ANN ARBOR HISTORIC DISTRICT COMMISSION**Staff Report****ADDRESS:** 203 East Washington Street, Application Number HDC17-098**DISTRICT:** Main Street Historic District**REPORT DATE:** June 8, 2017**REPORT PREPARED BY:** Jill Thacher, Historic Preservation Coordinator**REVIEW COMMITTEE DATE:** Monday, June 5, 2017**OWNER****APPLICANT****Name:** Washington/Fourth Condo Assoc.**Address:** 6255 Ledgeway
West Bloomfield, MI 48552**Phone:**

APPLICATION: The applicant seeks HDC approval to install 12 LED accent lights on the six windows along each building façade. Each would provide a narrow band of light flanking the windows along the first floor. The applicant also seeks approval to paint a 187 square foot logo directly on the brick along the Fourth Avenue façade, near the corner. New awnings are being proposed for ground level windows, which are black in color, with some featuring the business name along the valance. The storefront at 203 would have the modern wood shingles removed and the original steel beam exposed, and an awning installed at the same height as the awning on 201 immediately west. Finally, a wall sign and two projecting signs are proposed, one projecting from the seco

second story sign

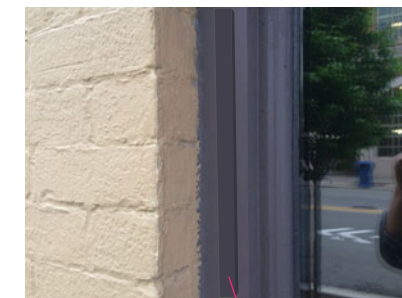
Remove cedar shakes and restore / match old details

Match soffit mass and detail

Expose original steel beam

Match horizontal beam and awning height of next door

LED window detail

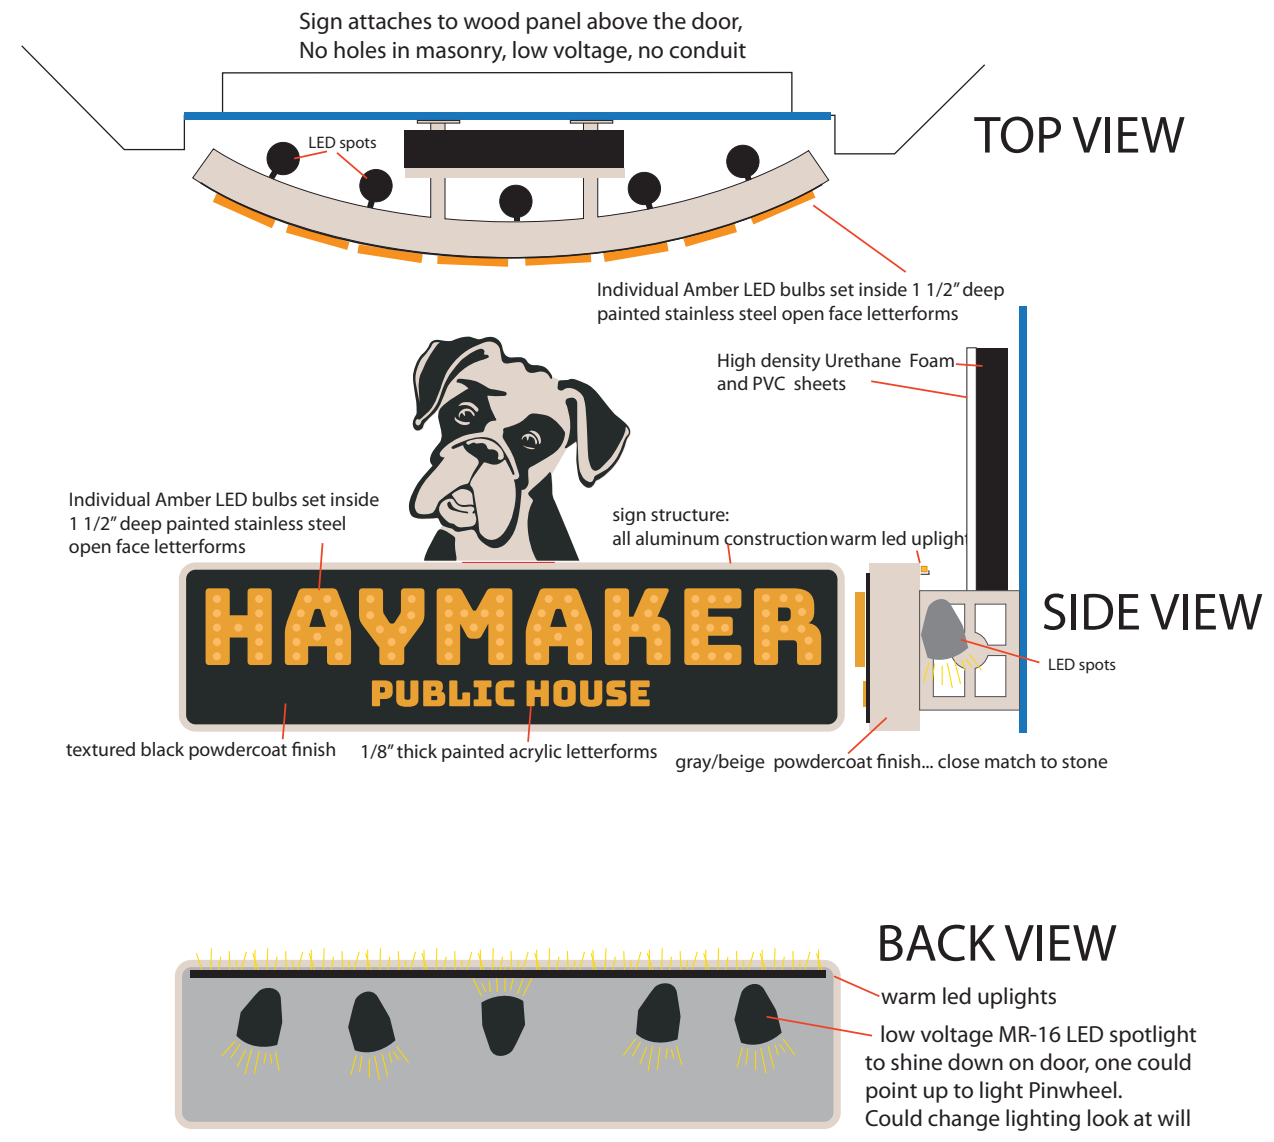
extrusion painted trim color

3000K LEDs

low voltage supplied through wood trim
no conduit
